Coal Combustion Waste Impoundment

Task 3- Dam Assessment Report

John E. Amos Plant (Site 26)

**Assessment of Dam Safety
Coal Combustion Surface Impoundments
for the REAC Program**

Figure 9.2.1-2. Location Map of Deformation Monuments.

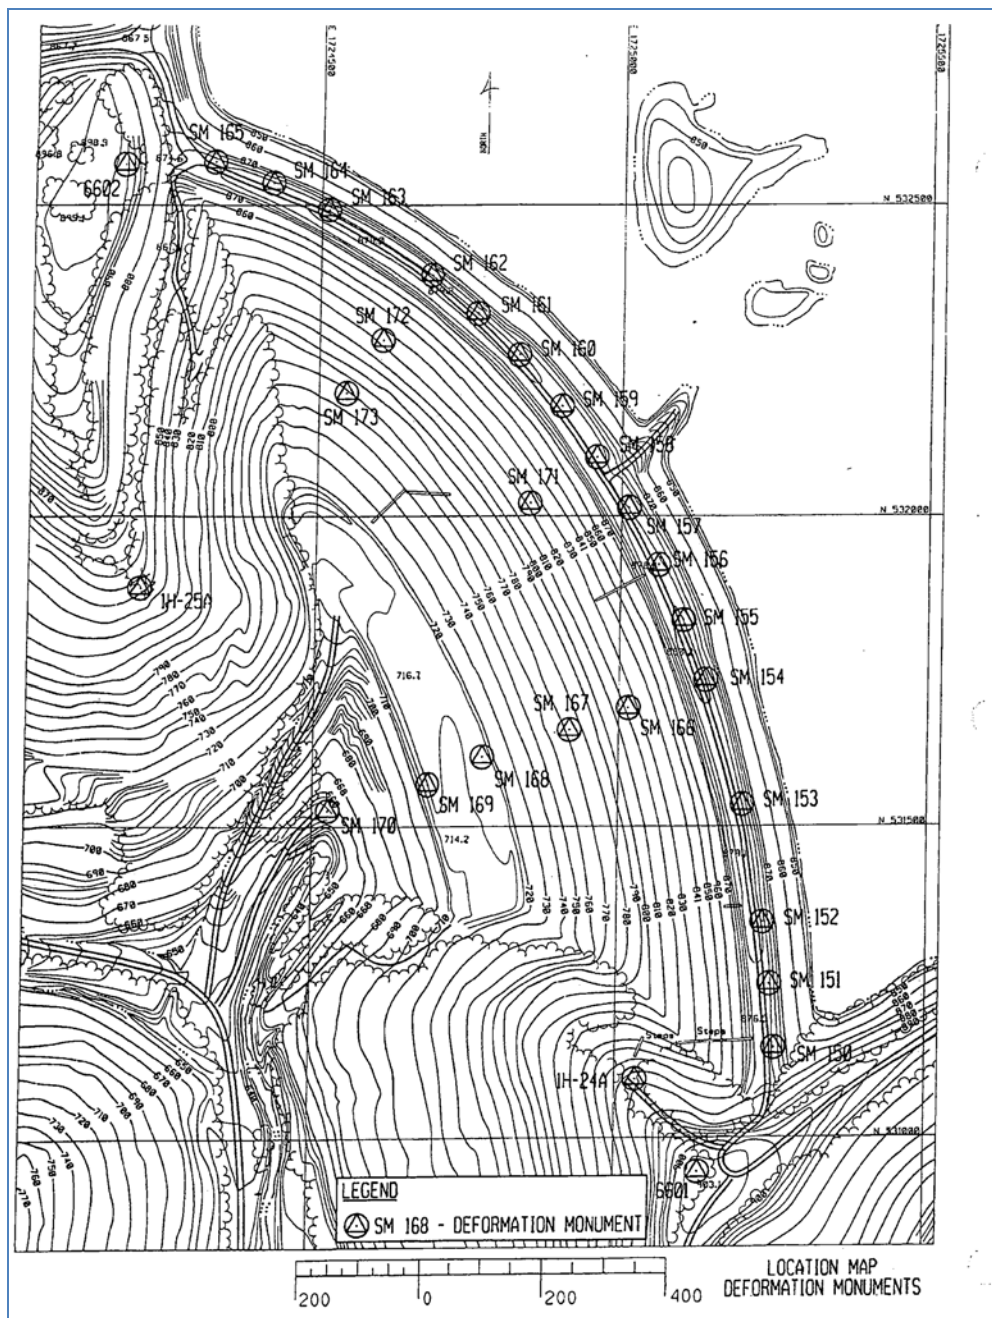
Deformation monitoring data are available for 23 points on the dam: 15 points along the crest and eight points on the downstream face of the dam. The dam configuration and location of monitoring points are shown on Figure 9.2.1-1.

Figure 9.2.1-3. Location Map of Piezometers.

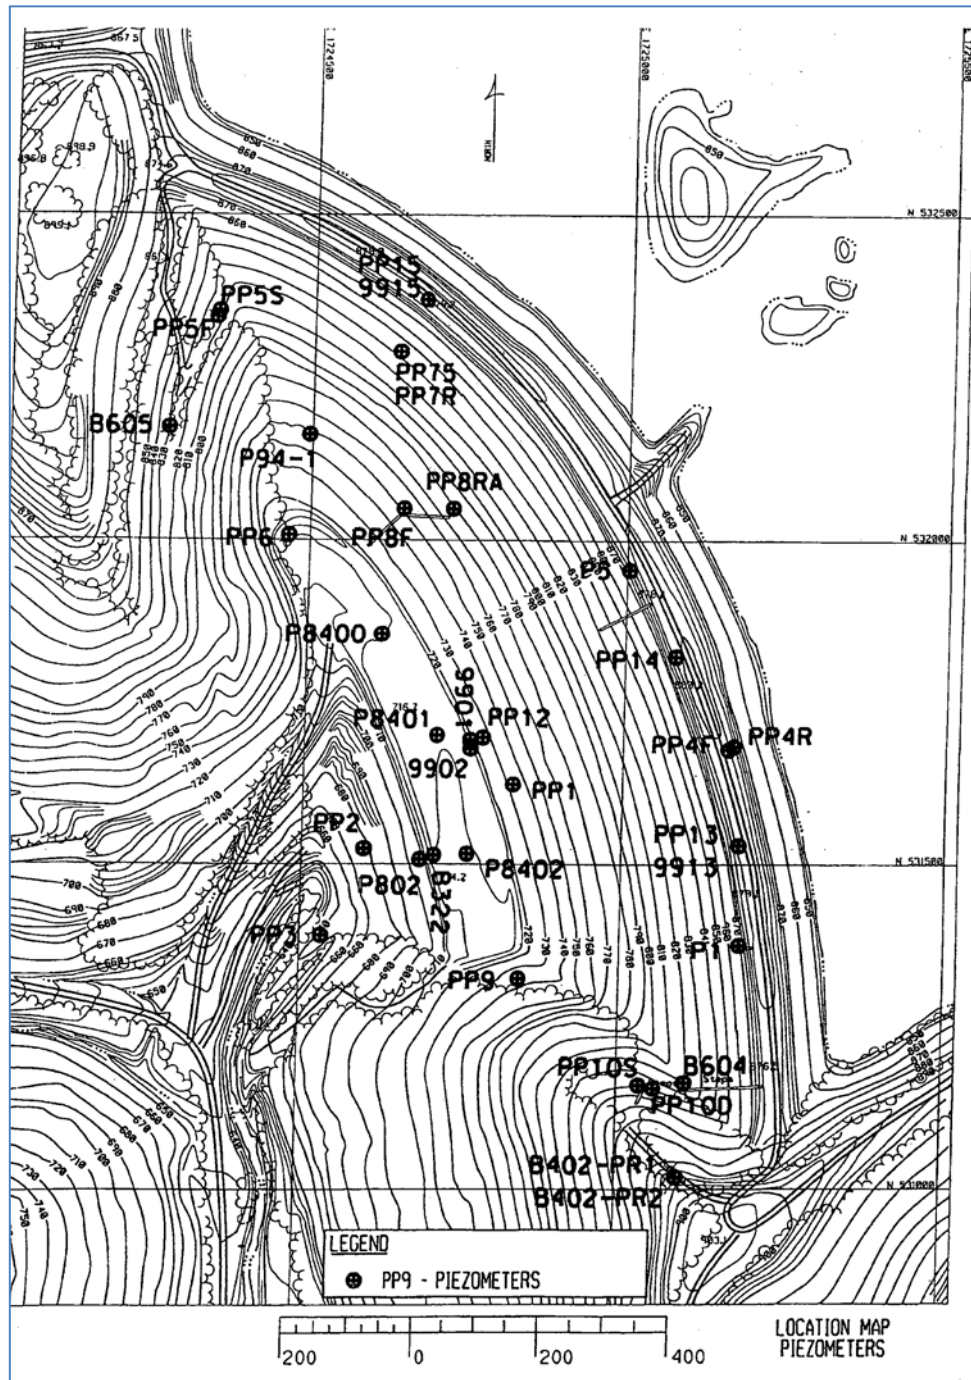
Piezometer readings are obtained monthly for eleven piezometers and quarterly for the remaining 26 by John Amos personnel using a battery powered Sinco water level indicator. Figure 9.2.1-3 is the location map of the piezometers.
